January 12, 2001

The Egyptian Civil Aviation Authority requests and authorizes you to place the Response of EgyptAir to October 31, 2000 Submission of The Boeing Company regarding the EgyptAir Flight 990 investigation into the public docket for the EgyptAir Flight 990 investigation.

Response of EgyptAir  
to  
October 31, 2000 Submission of  
The Boeing Company  
Regarding  
The EgyptAir Flight 990 Investigation

Figure 26. B-767 Ground Test Results Extracted from Boeing CD Compared to Boeing Mathematical Lumped Mass Elevator Model, Single PCA Jam, Condition A

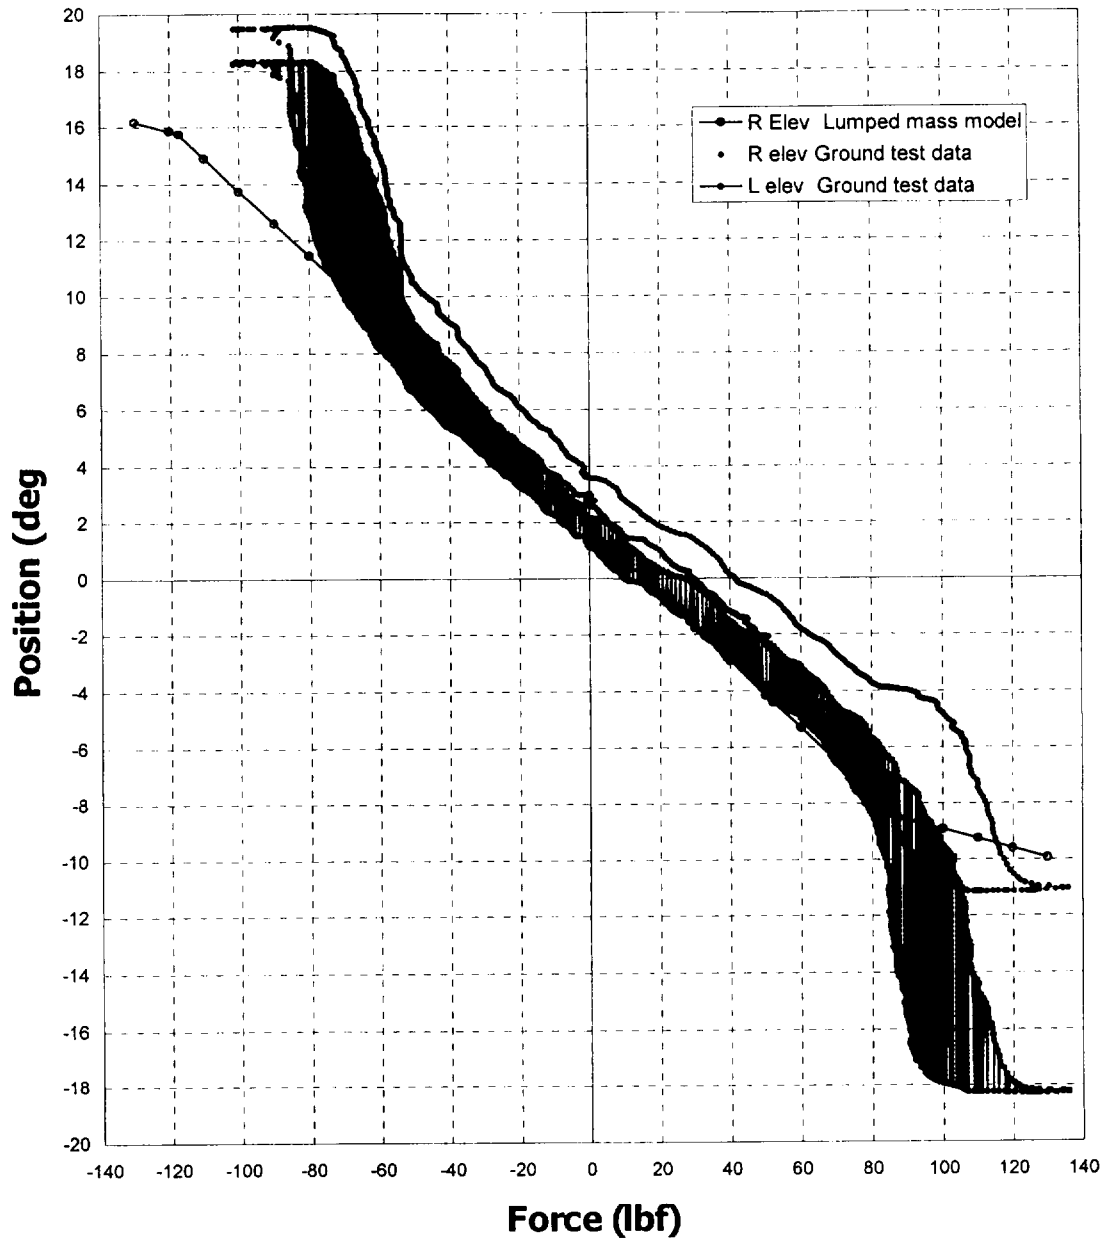
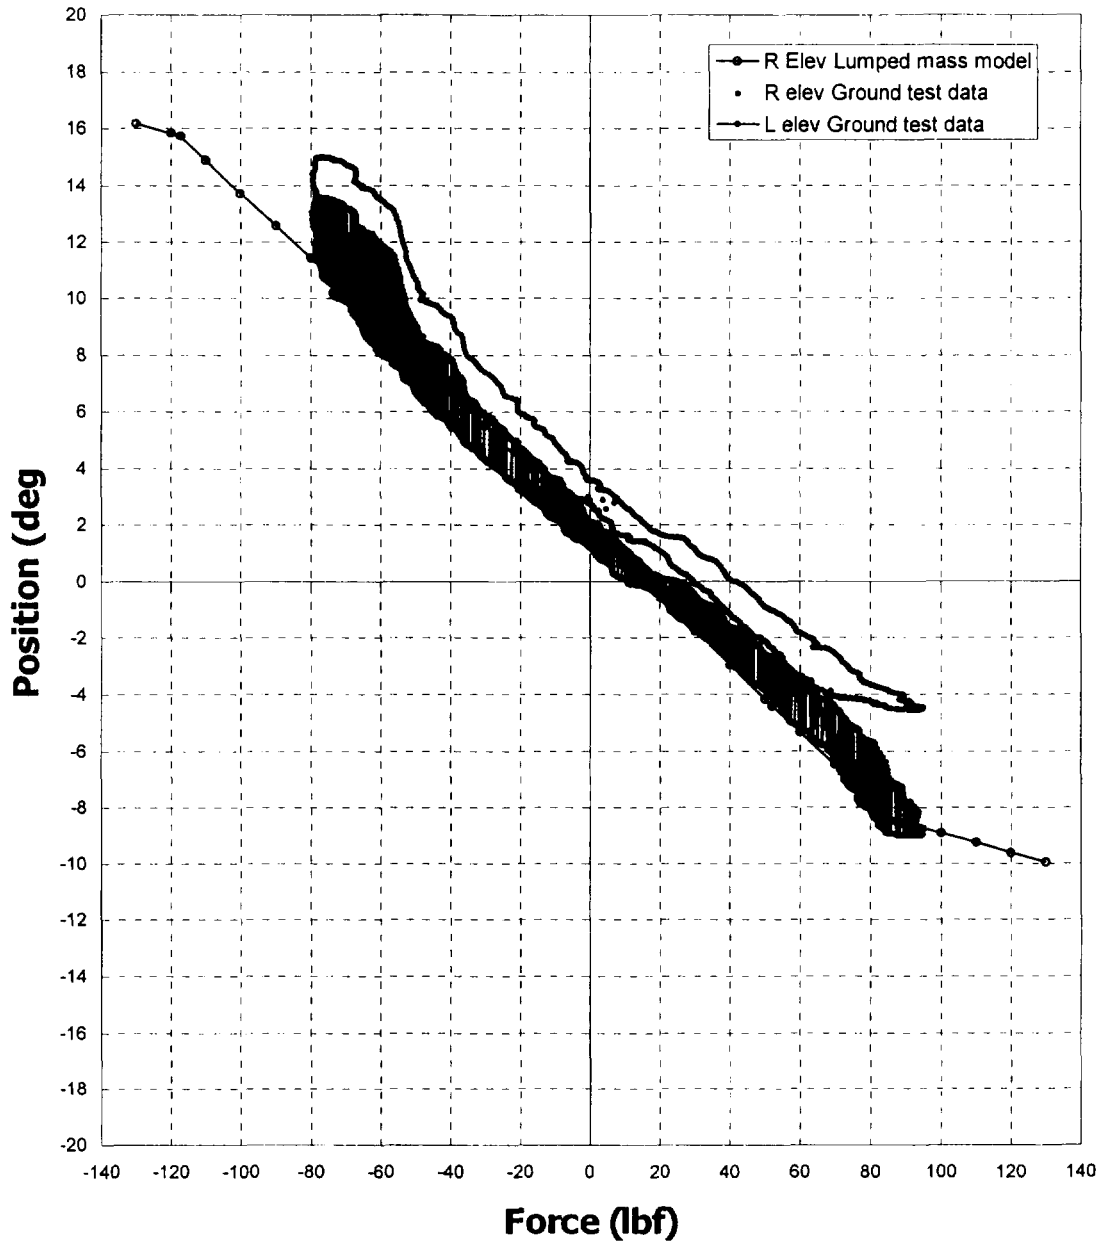
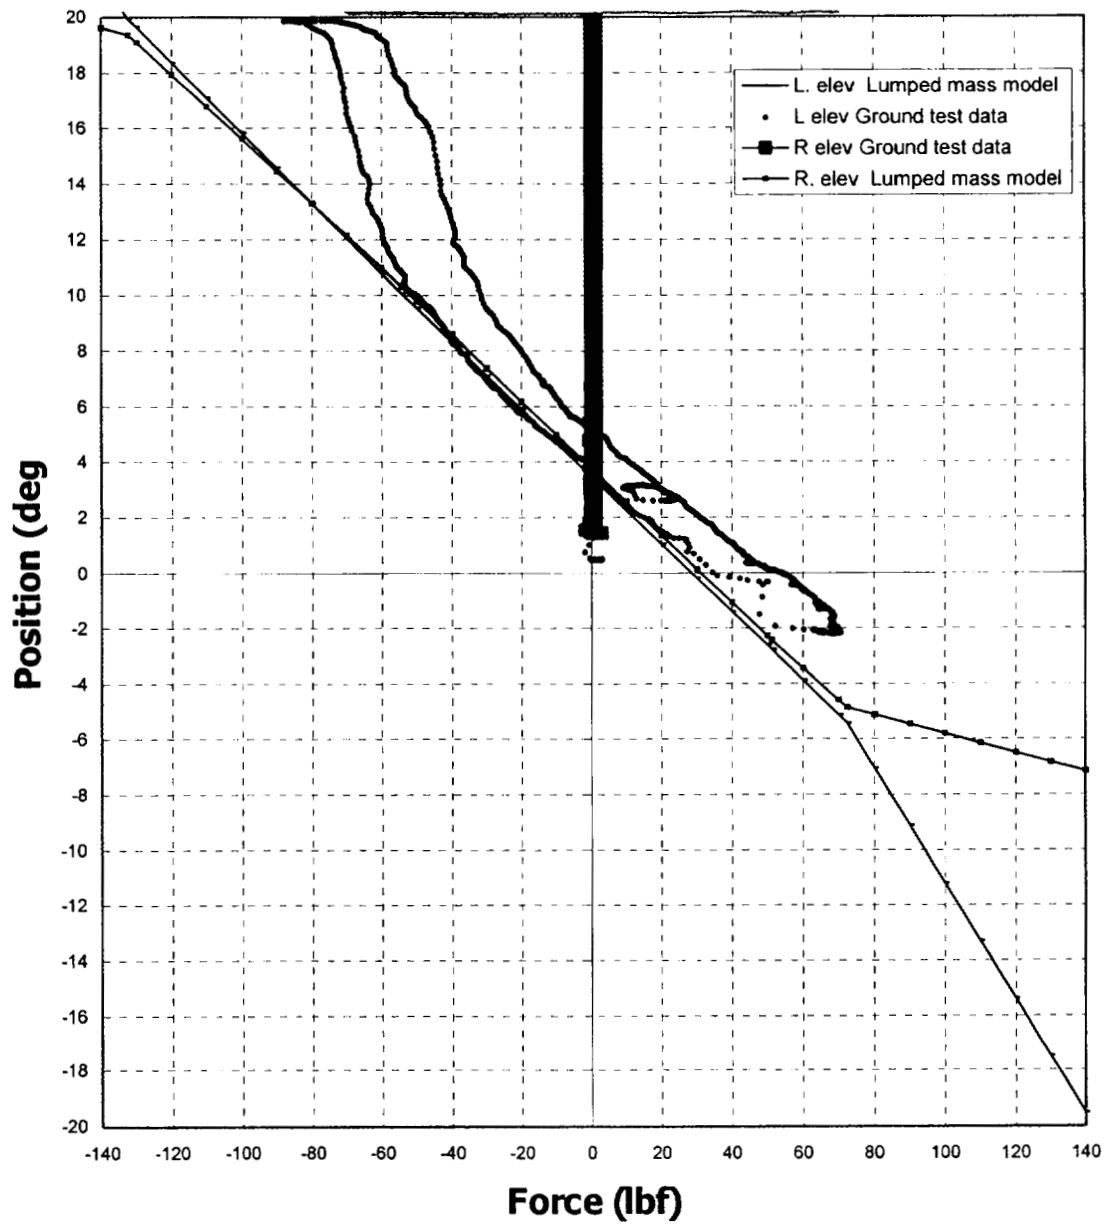
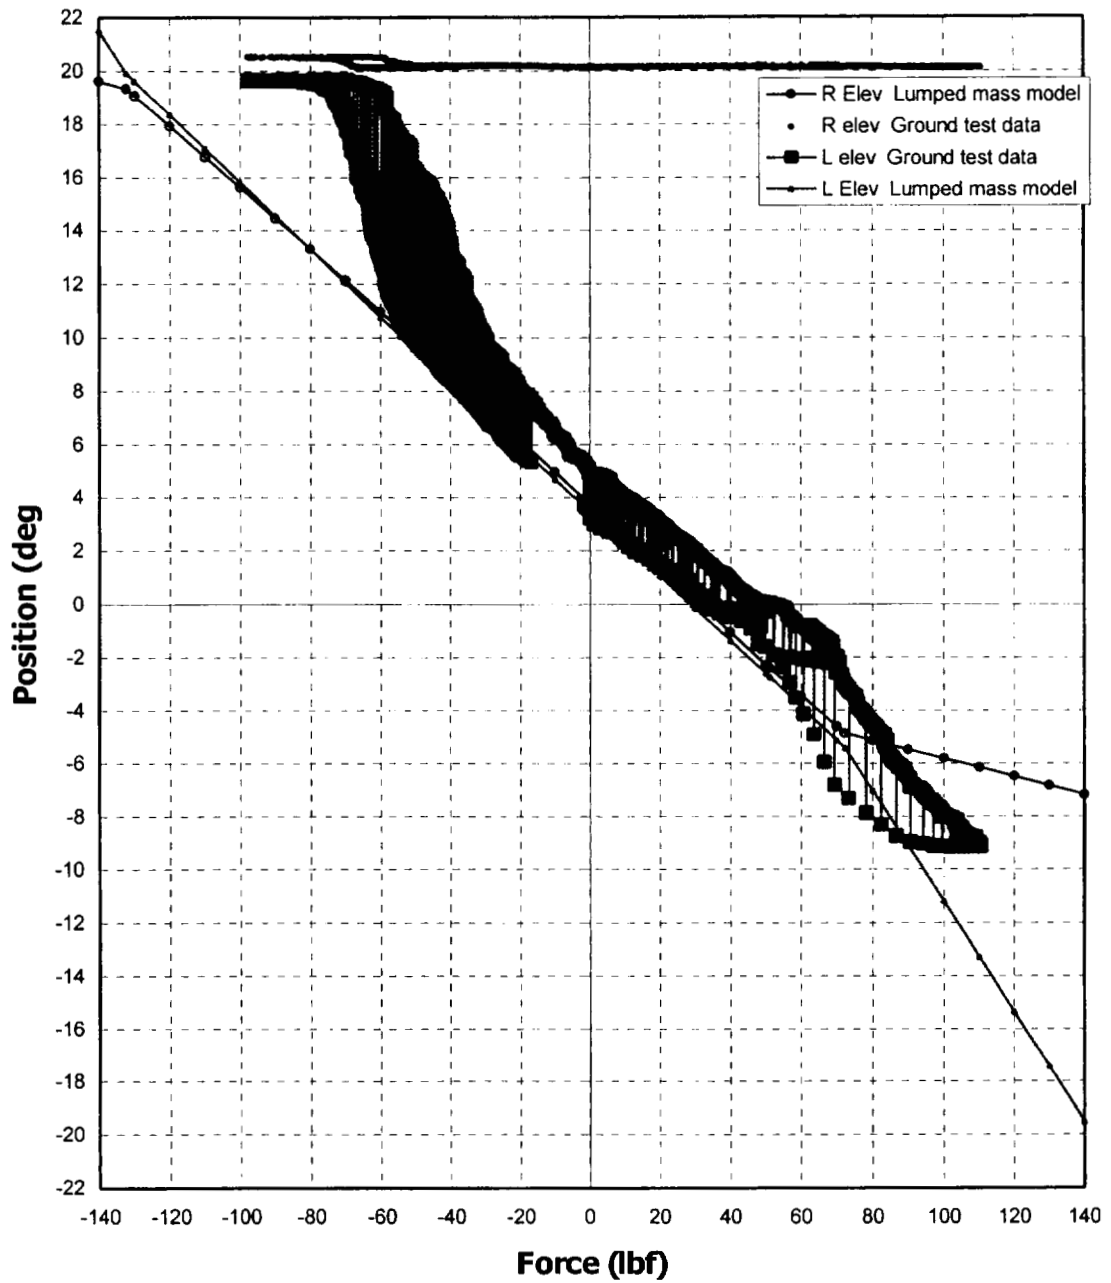
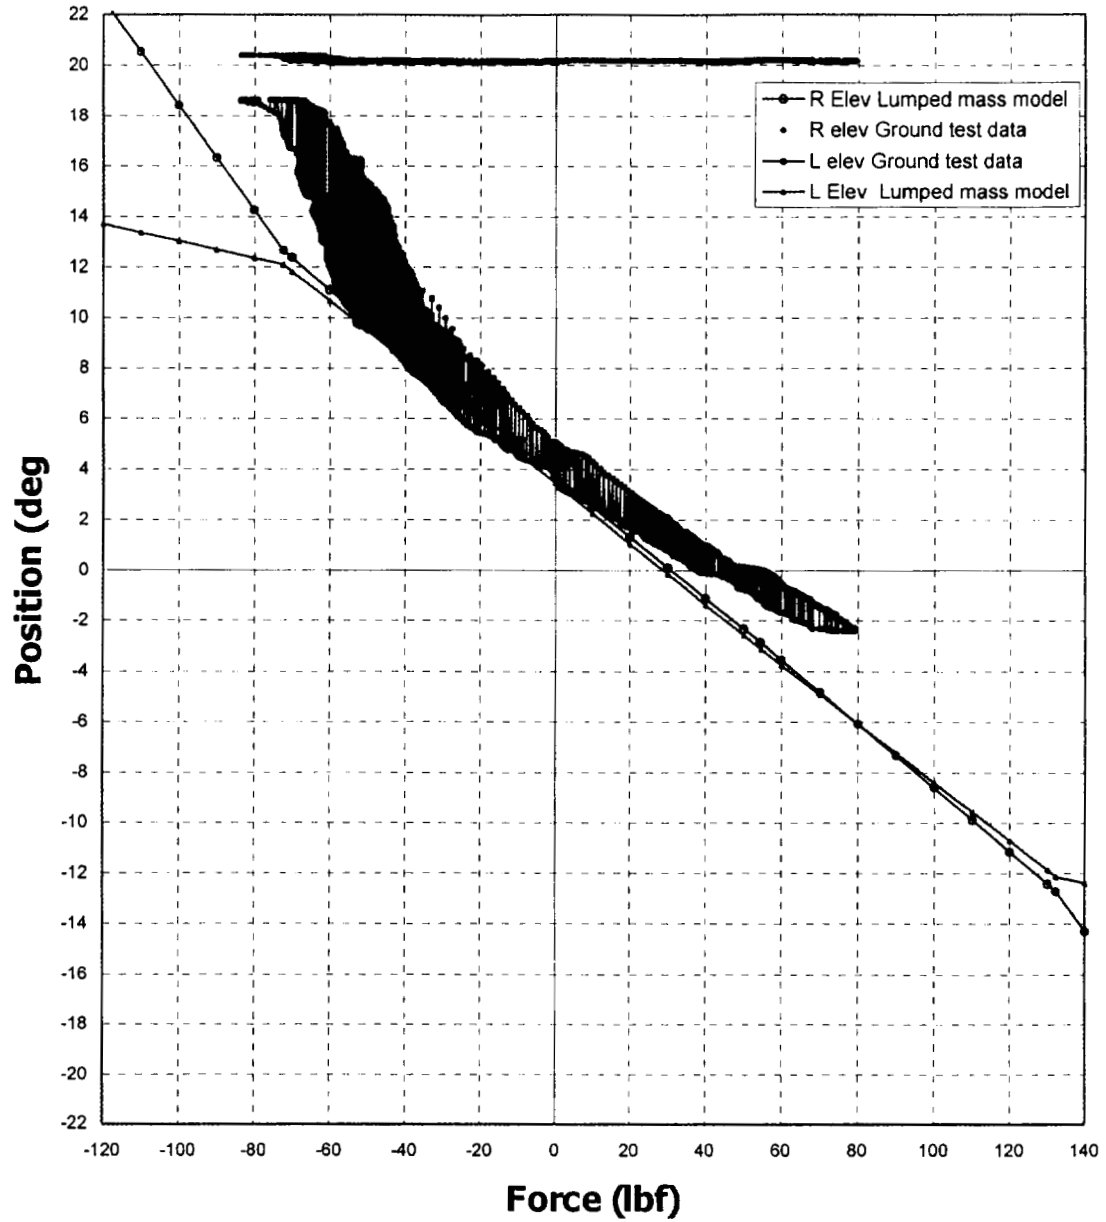
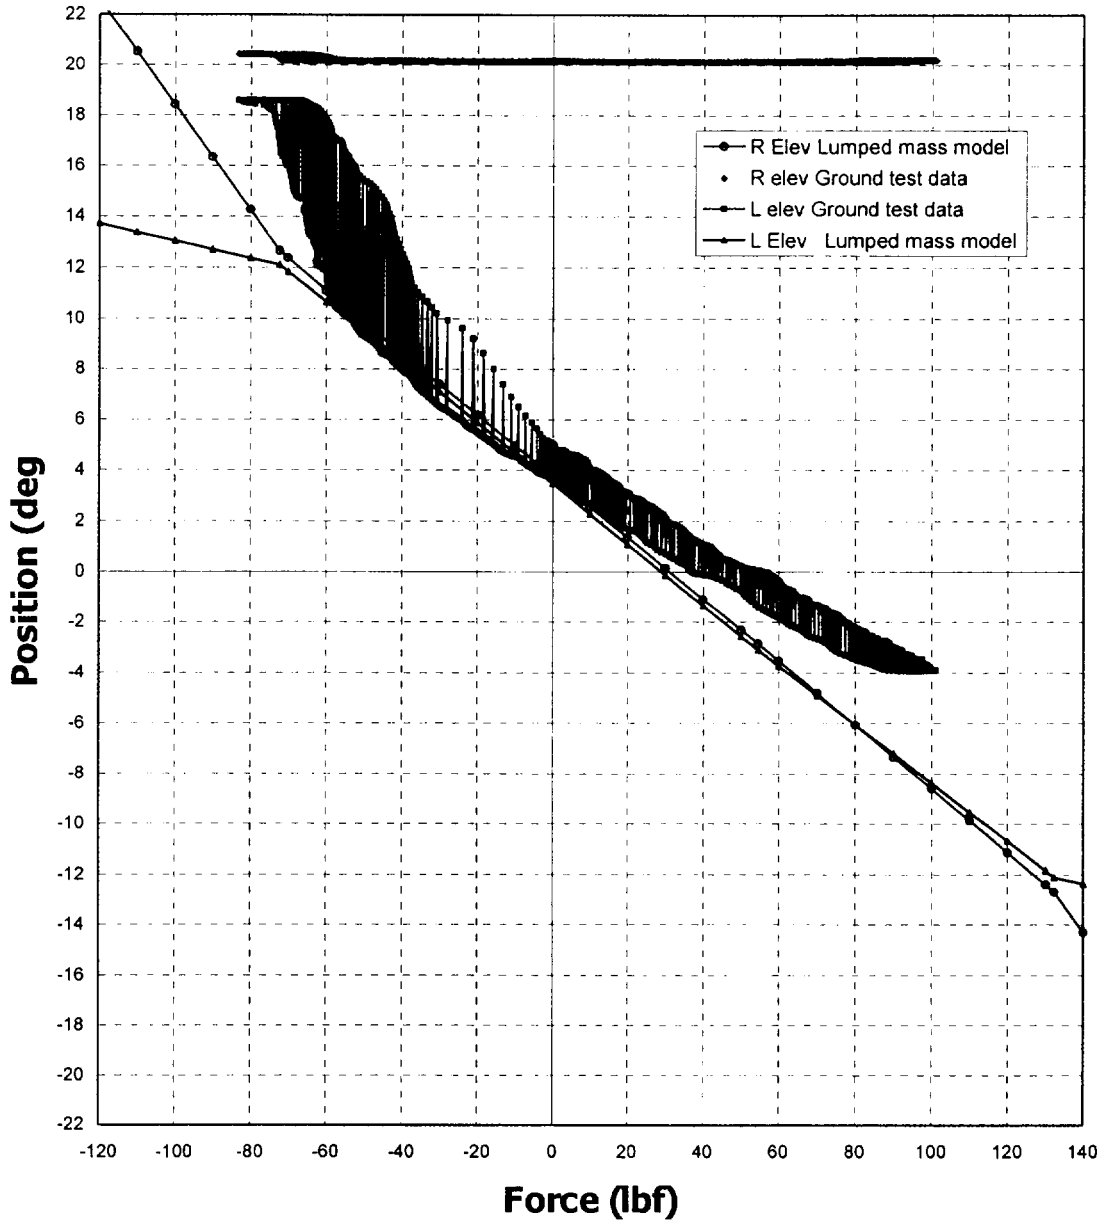
Finally, the data gathered during the ground tests conducted on the 767 does not support the Boeing study regarding single and dual PCA failures. In addition, the data does not correspond with the mathematical description of the elevator control system previously provided by Boeing. See Figures 28-31. These Figures present the elevators deflection as obtained from Boeing analytical model and the 767 ground test.

As shown in these figures, the “elevator force – deflection relationship” obtained from the 767 ground test is not consistent with the relationship obtained analytically in Boeing report B-H200-17068-ASI-R2 (Split Elevator Failure Scenario, dated September 29, 2000) and Boeing

report B-H200-17026-ASI, (767 Elevator System Operation with Regard to Column Splits, Aft Quadrant Splits, and Column Jams, dated August 2, 2000). The actual ground test results always show much higher force at the same elevator deflection compared with Boeing analytical results on which Boeing based most of its conclusions.
